**WATER RESOURCES DEPARTMENT**

# Groundwater Application Review Summary Form

Application # G- 18965

PUBLIC INTEREST REVIEW FOR GROUNDWATER APPLICATIONS

Water-Level Trends in Nearby Wells

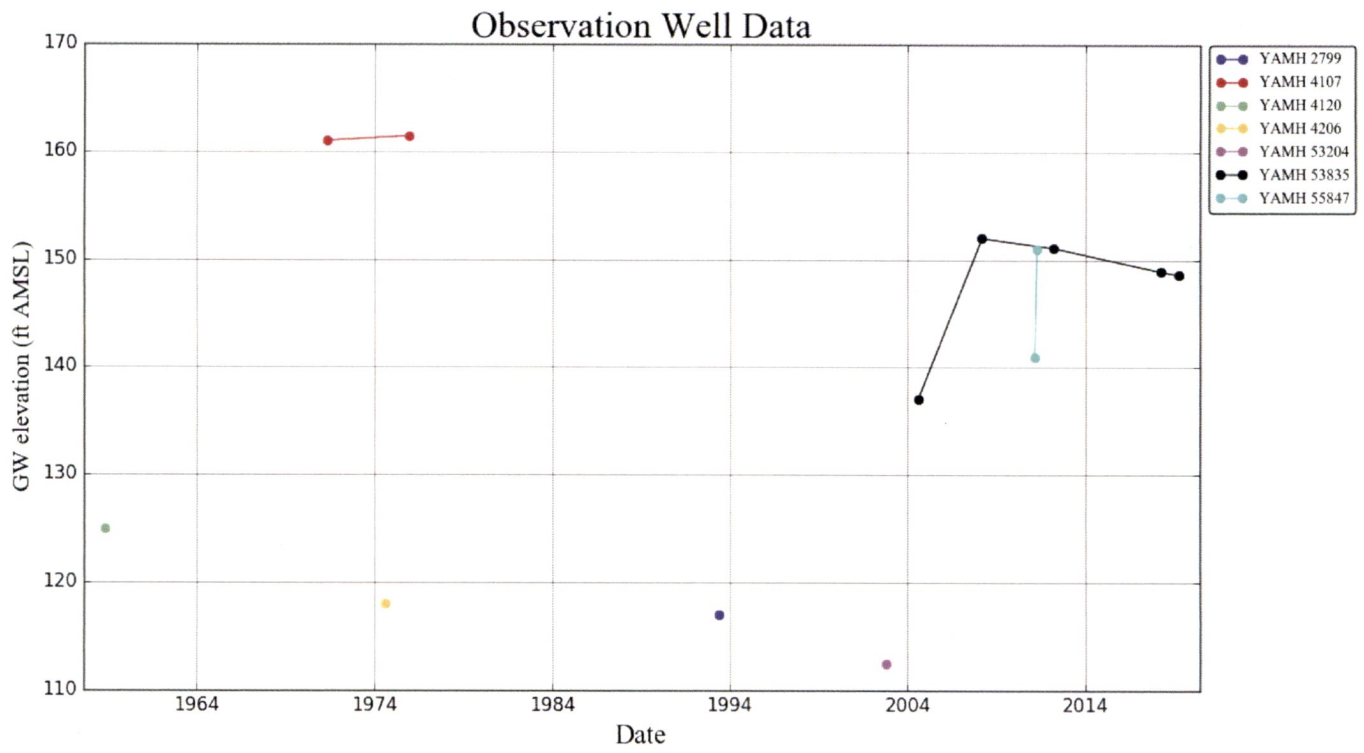
B3. **Groundwater availability remarks:** The subject site is characterized by low-yielding fractured marine sedimentary rock aquifers. A survey of well logs in T3S/R3W-Sections 11, 12, 13 and 14 produced 212 new well logs, with reported yields ranging from 0 to 160 gpm. The median yield is 12 gpm and most logs report sandstone, claystone and/or shale. This is typical of the low-yield bedrock hydrogeologic unit described at this location by Conlon et al. (2005). The marine sedimentary aquifers generally exhibit long-term, climate-related water level fluctuations. Water level data from nearby wells in this aquifer are sparse. The resource cannot be appropriated to be over-appropriated based on the limited time-series data; YAMH 53835 is the only well within 1 mile with multiple measurements and the trend is unclear (see Figure 3). The marine sedimentary aquifers generally exhibit long-term, climate-related water level fluctuations. Given the small (1 gpm) rate and total volume (less than 1 acre-foot) requested, it is unlikely the proposed use will injure other groundwater users. In the event this permit is issued, water use and water level monitoring conditions are recommended to address uncertainty about resource sustainability.
